STAFF RECOMMENDATION

REVISED – July 7, 2005
N. Witherell
NCPC File No. 6265

LINCOLN MEMORIAL LINCOLN MEMORIAL CIRCLE SECURITY IMPROVEMENTS, EAST SIDE – BARRIER LOCATION WASHINGTON, DC

Submission by the National Park Service

OPTION 4

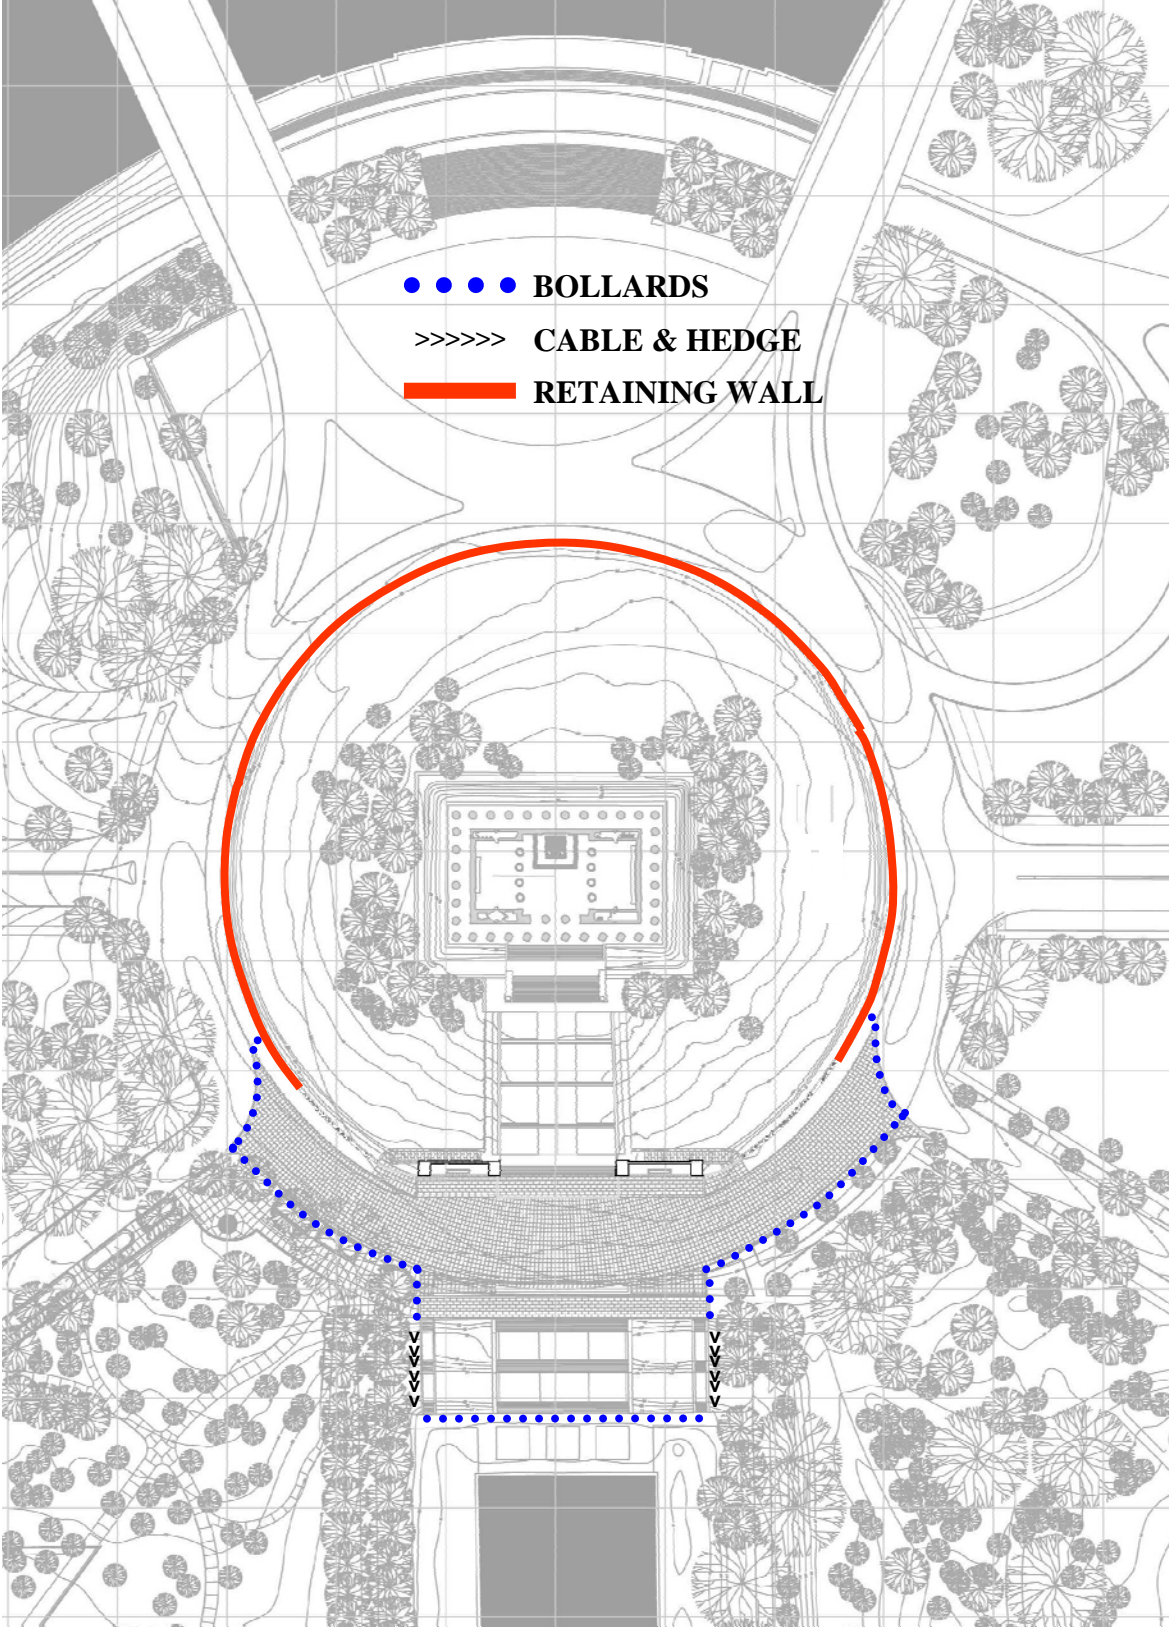
Approves a security barrier line location (the design is not yet fully determined) that crosses Memorial Circle at Bacon and French Drives and that descends the lower stairs to the level of the Reflecting Pool, as shown in Option 4 of NCPC Map File No. 1.44(38.40)41628.

- Use a cable fence or other barrier with paired hedges parallel to the lower stairs.
- Develop a barrier design for the base of the lower stairs that will preserve the integrity of the grass terraces in relation to the stairs.
- Terminate the retaining wall (now under construction around Memorial Circle) at a point east of Bacon and French Drives but before reaching the access ramps.
- Study a pavement pattern that combines a radial layout of 4-foot by 4-foot pavers around the eastern portion of Memorial Circle and an orthogonal pattern in the central axis.
- Develop and test in the field a bollard design for the approved barrier location that is appropriate for the setting—austere in design, in a dark color or finish.

The current proposal recommended by the staff is “Option 4.” This scheme has a longer barrier line than the Commission has seen in recent submissions, although it is similar to the original 2002 design concept. It acknowledges that the landscape will be altered regardless of the scheme selected, and emphasizes that the principal objectives are to avoid the alteration of original fabric and to treat the lower stairs as integral to the original design of the memorial. Option 4 does add elements to the landscape below the circle, something that had been previously deliberately avoided. Option 4 has the benefit of avoiding as much as possible the appearance of bollards in the viewshed from the top of the memorial. It does increase the visibility of the barrier line from the Reflecting Pool. Staff notes that the material at the base of the lower stairs, between them and the Reflecting Pool, is concrete and non-historic (rather than granite). The alteration of granite surfaces for bollards has been a concern with other schemes, including the scheme recommended by the staff at the April meeting.

Instead, Option 4 was developed on July 6, 2005. Staff suggested to the National Park Service the extension of the bollard line (proposed for the center stairs) across the fronts of the grass terraces as well. This proposal was discussed at length at the site visit on July 6; NPS will design the option and present it to the Commission at a future meeting. The Commission of Fine Arts will consider it at its July 21 meeting. Although a longer bollard line at the base of the lower stairs is created in Option 4, the bollards would be seen against the grass terraces, which would minimize their visual impact. Further, the terraces would be seen in their entirety without alteration from the Mall level (through the bollards), thus preserving their symbolic relationship to the Mall, the stairs, and the memorial itself. A retaining wall, planters, or a cable-and-hedge system would fundamentally alter this design intent. The bollards would be installed in front of the grass terraces in non-historic concrete pavement. And, significantly, the terraces themselves and the sides of the lower stairs would not require alteration.
